Intel[®] Pentium[®] III Processor Specification Update

Release Date: May 2002

Order Number: 244453-041

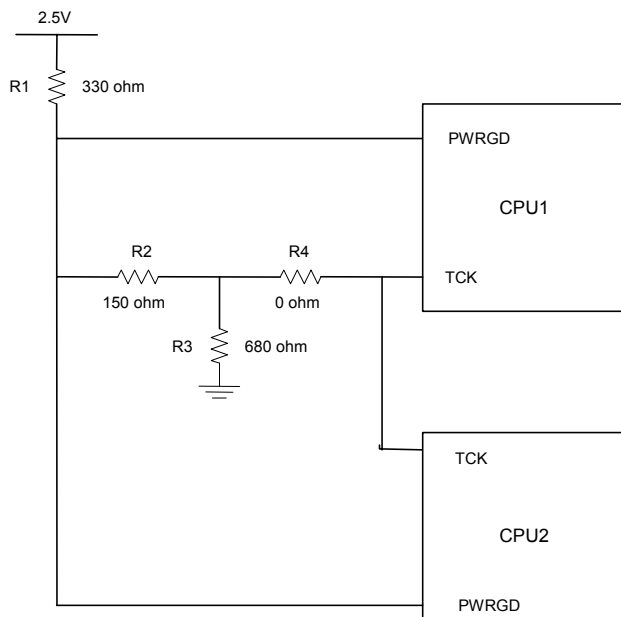
Problem: The internal control register bit responsible for operation of the Thermtrip circuit functionality may power up in a non-initialized state. As a result, THERMTRIP# may be incorrectly asserted during de-assertion of RESET# at nominal operating temperatures. When THERMTRIP# is asserted as a result of this erratum, the processor may shut down internally and stop execution but in few cases continue to execute.

Implication: This issue can lead to intermittent system power-on boot failures. The occurrence and repeatability of failures is system dependent, however all systems and processors are susceptible to failure. In addition, the processor may fail to stop execution during the event of a valid THERMTRIP# assertion resulting in the potential for permanent processor damage.

Workaround: To prevent the risk of power-on boot failures or catastrophic thermal failures, a platform workaround is required. The system must provide a rising edge on the TCK signal during the power-on sequence that meets all of the following requirements:

- Rising edge occurs after Vcc_core is valid and stable
- Rising edge occurs before or at the de-assertion of RESET#
- Rising edge occurs after all Vref input signals are at valid voltage levels
- TCK input meets the Vih min and max spec as mentioned in EMTS
